GOVERNMENT OF MADRAS.

PUBLIC WORKS DEPARTMENT.

Buildings and Roads.
Civil Works.

The estimate, amounting to Rs. 10,200, for a building at Bellary to accommodate the offices of the District Board Local Fund Engineer and Taluk Board is sanctioned.

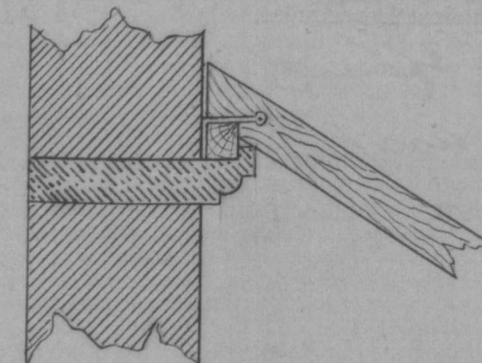
2. Instead of inserting the ends of the verandah rafters in the wall, they might be carried on wall purlins supported by stone corbels, thus :—

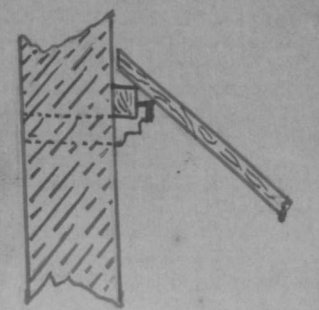
2. Instead of inserting
the ends of the veranda
rafters in the wall,
they might be carried
on wall purlins supported
by stone corbels thus:—
